Technical Service Information

Title **FRONT STABILIZER BUSHING NOISE**

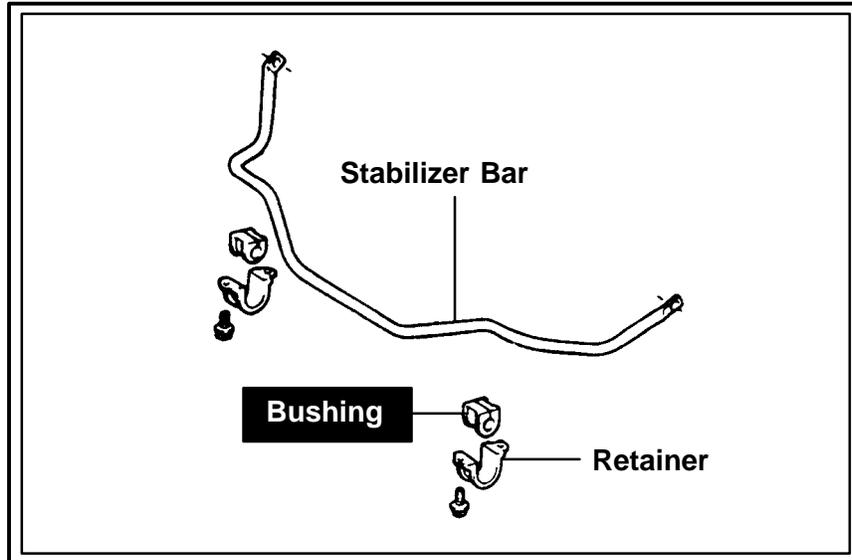
A new teflon lined front stabilizer bushing is now available to eliminate front stabilizer bushing noise. This new bushing was introduced on the 1995 LS 400, and will also fit '90-'94 model year LS 400's.

PREVIOUS PART NUMBERS	NEW PART NUMBER	DESCRIPTION	QTY.
48815-50011 48815-50120	48815-50121 "	Stabilizer Bushing "	2

Both front bushings must be replaced as a set.
